DESIGN ADVISORY BOARD Tuesday, July 28, 2015 at 3:00 PM Conference Room 12, City Hall, Burlington, VT

1. **16-0007CA/MA & 16-0015CA; 329-351 North Ave, (RMW, Ward 4N) Eric Farrell**
Convert former orphanage & college building to 63 residential units and relocate college w/in building. Associated site improvements.

MEMORANDUM

To: The Design Advisory Board
From: Mary O'Neil, AICP, Senior Planner
RE: ZP16-0007CA/MA 351 North Avenue
Date: July 28, 2015

**EXISTING
CONDITIONS
OVERALL SITE
PLAN**

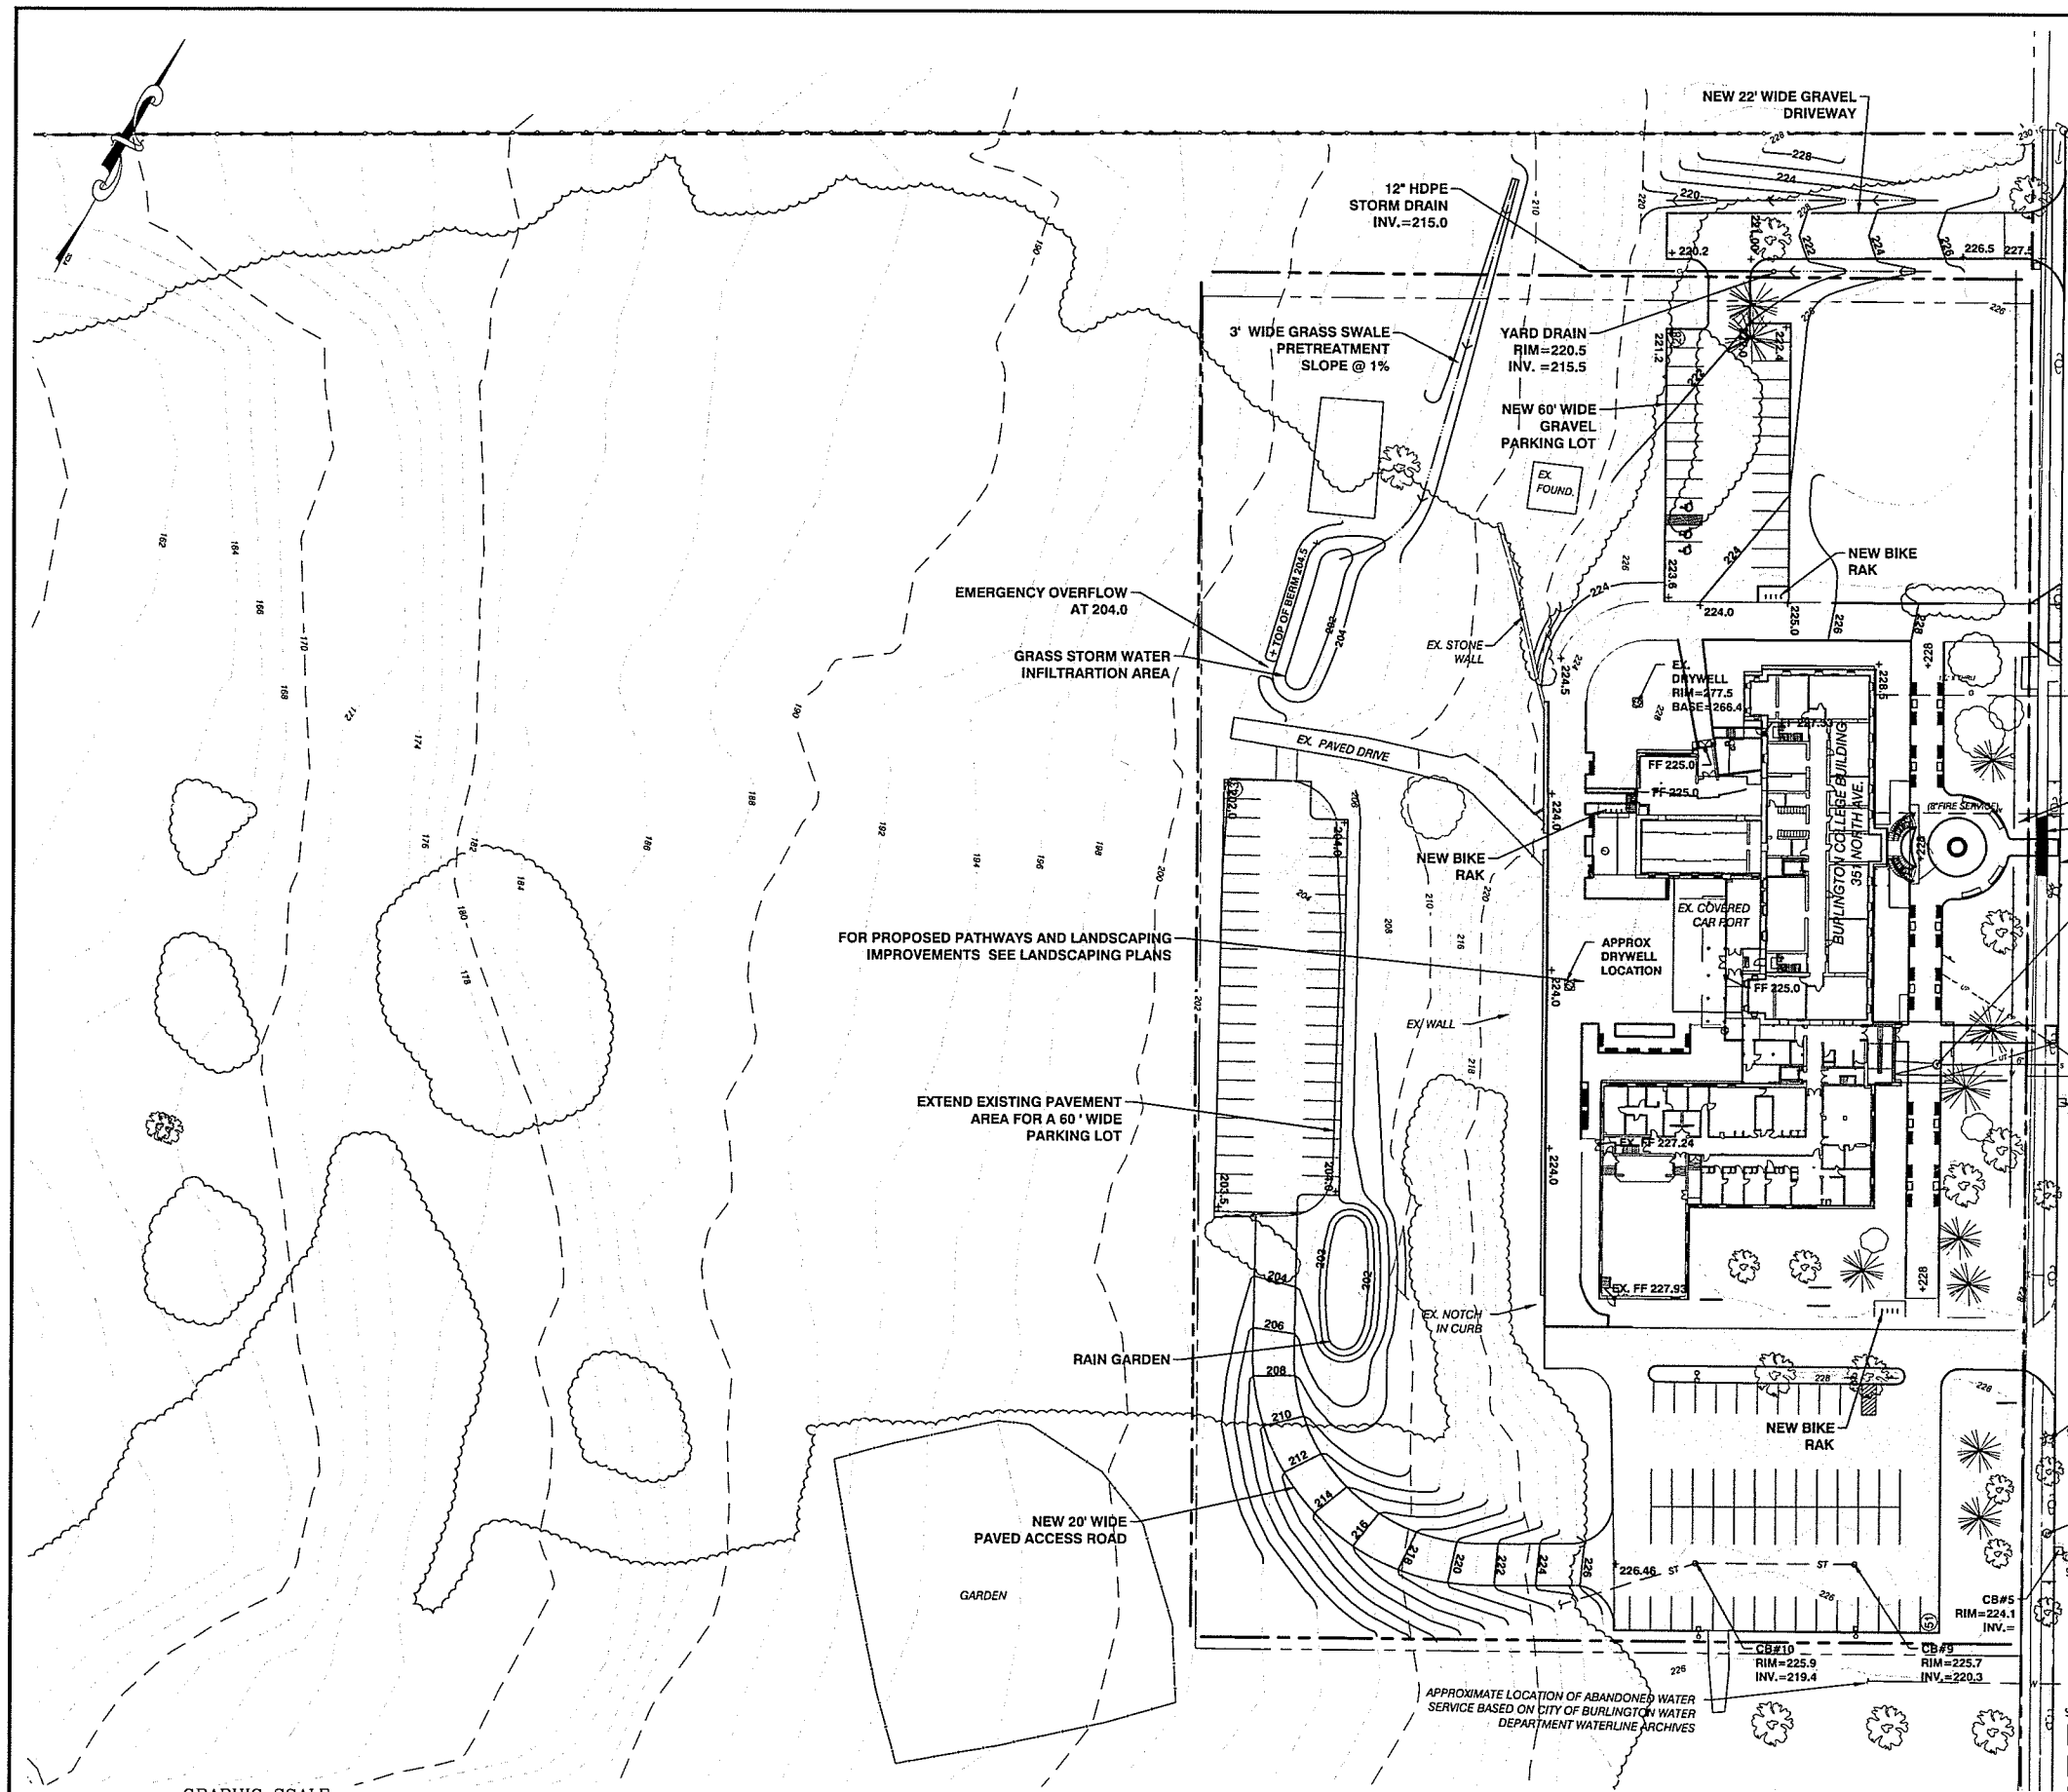
Existing retaining/stone walls illustrated on Plan C1.1 are not noted in landscaping plans. It is assumed that they will be removed for completion of the patio area. The applicant will need to confirm.

C4.0

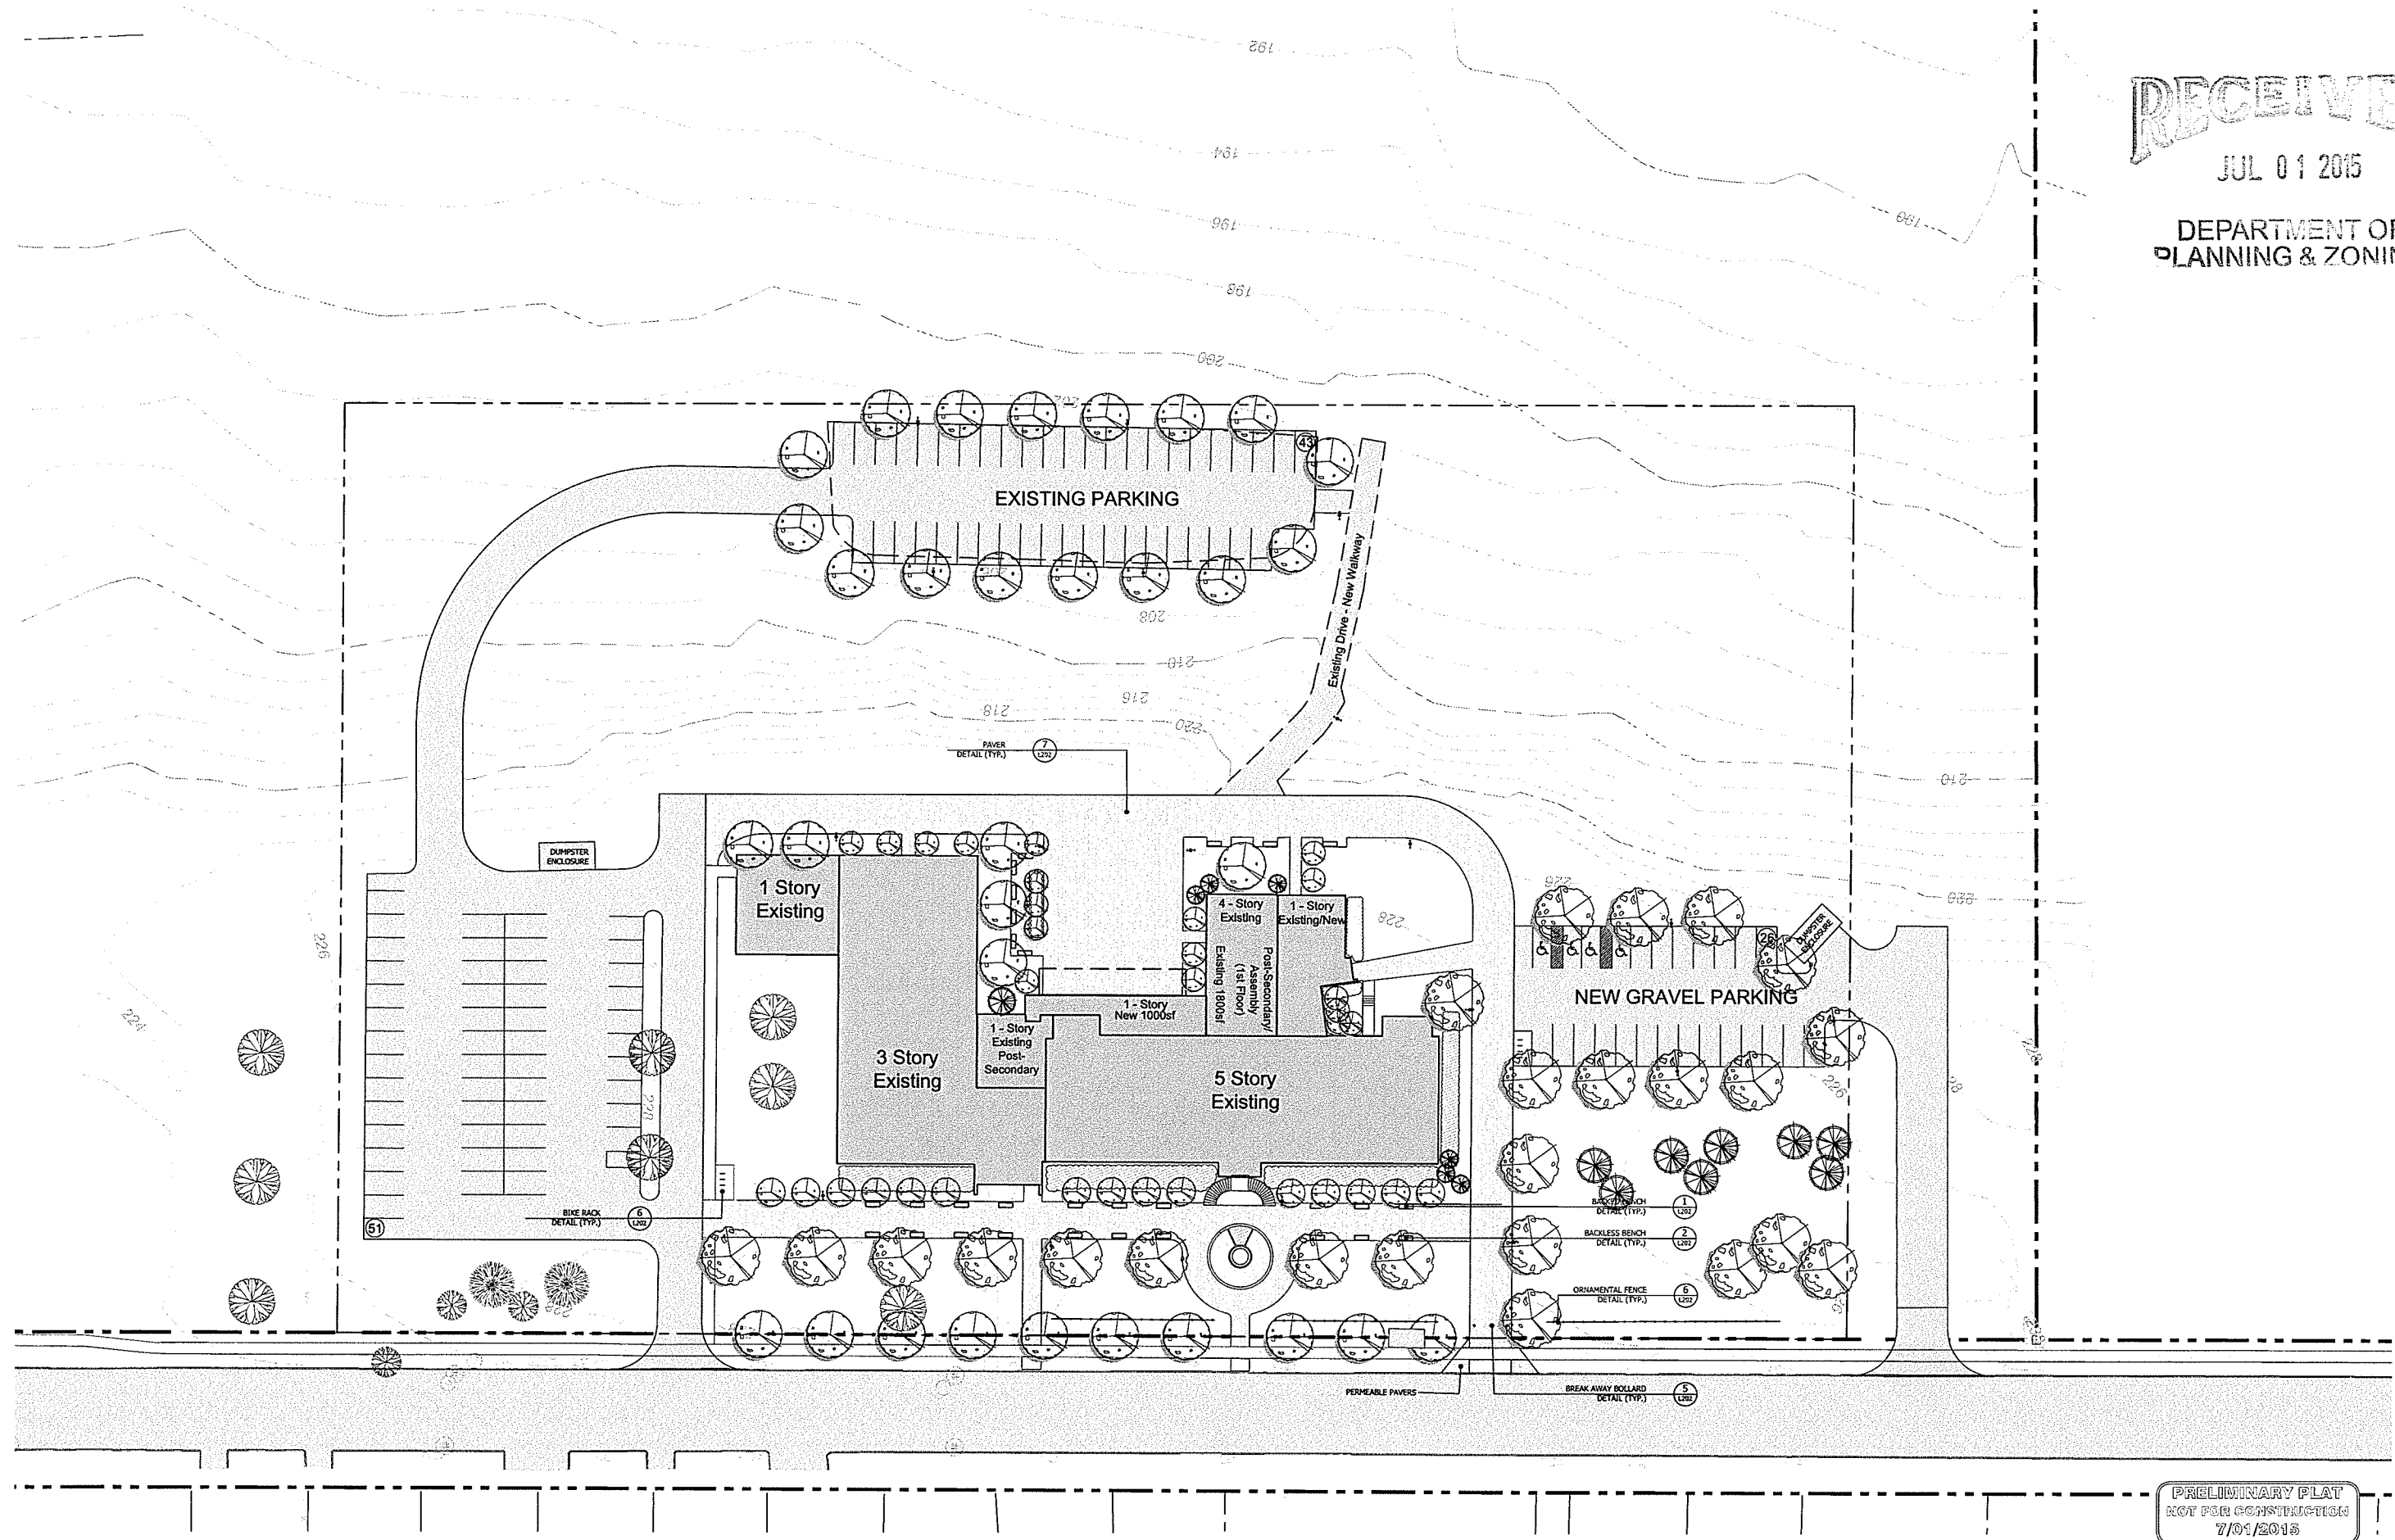
The circulation pattern, as illustrated on Plan L-103 has met preliminary approval of the fire marshal for emergency access. In that plan, knock-down bollards are utilized at the street entrance to eliminate regular vehicular circulation. See Plan L-202 for detail on collapsible bollard (although labeled as “Thayer Commons Site Details.”)

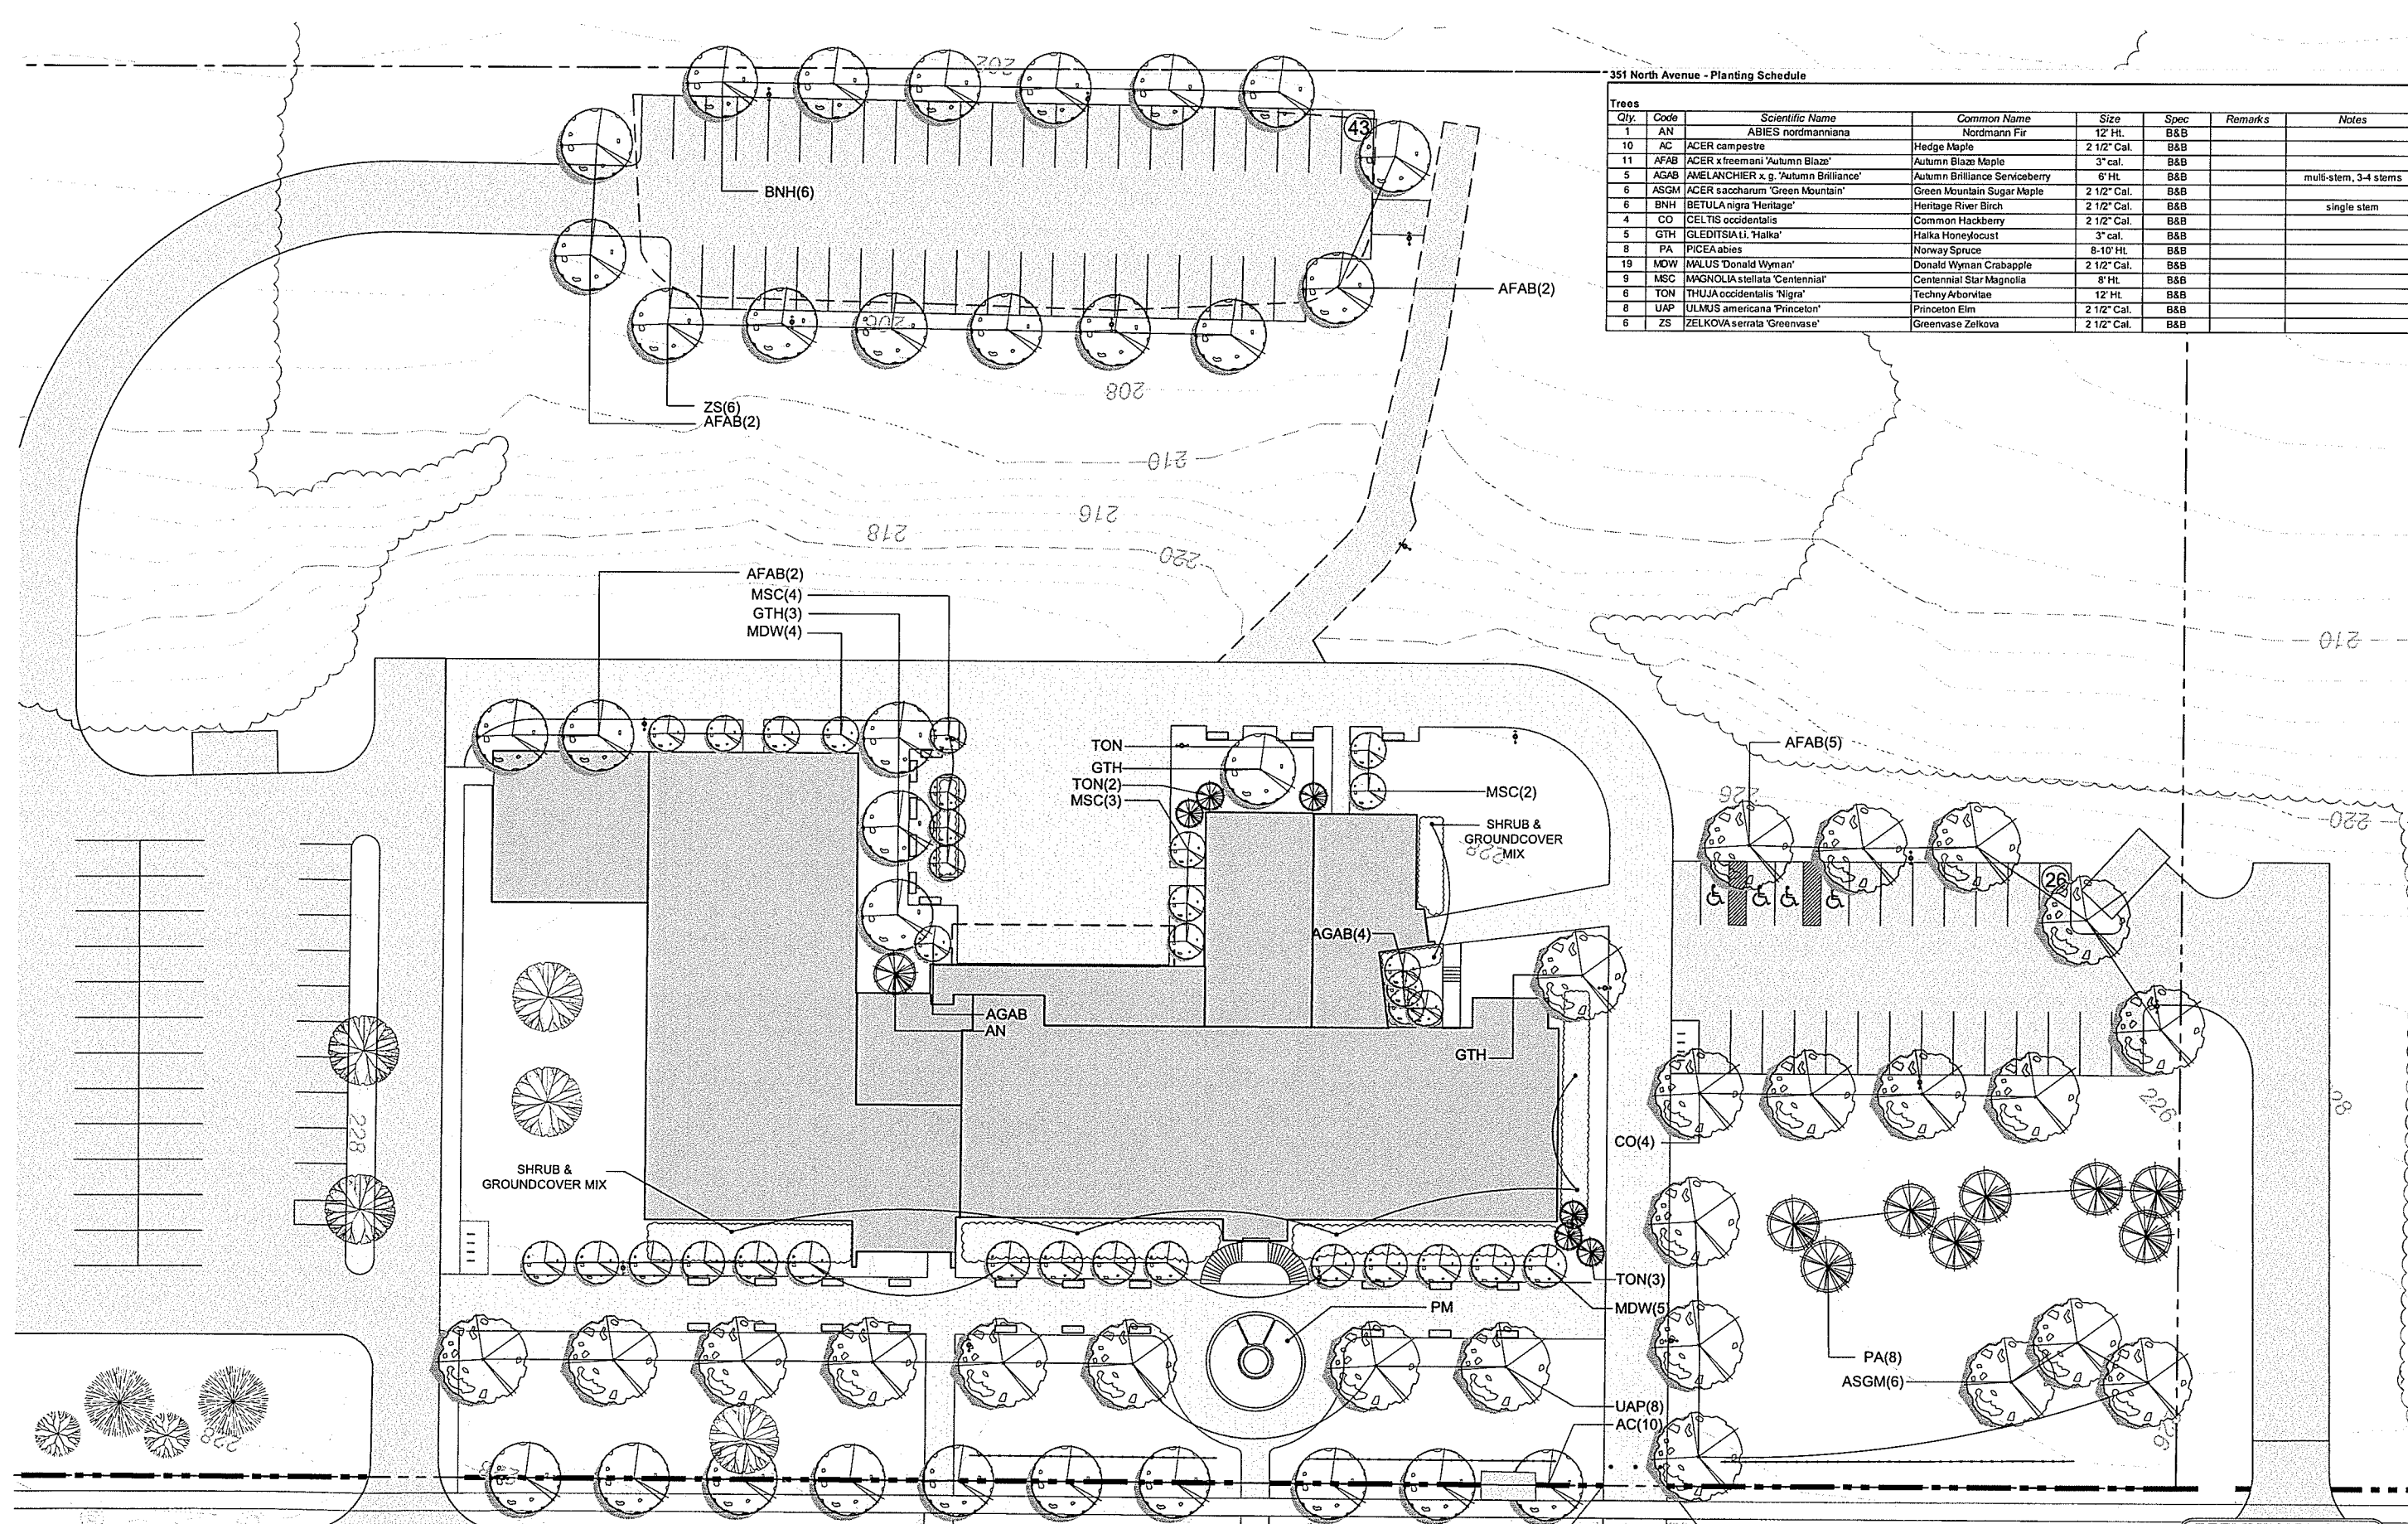
1. The new (north) parking lot, with more than 20 spaces (26 or 28 illustrated, depending on plan), is required to be broken up into smaller areas separated by landscaping to meet Section 6.2.2 (l.).

The DAB may determine that the small “island” between the parking area and the dumpster location on Plan L-100 and L-102 meets this standard.

4. The dumpster must be set back from the property line at least 5'. As illustrated in Plan L-100, it encroaches within a required setback.
5. The number of bicycles accommodated needs to be provided to assure compliance with Article 8.
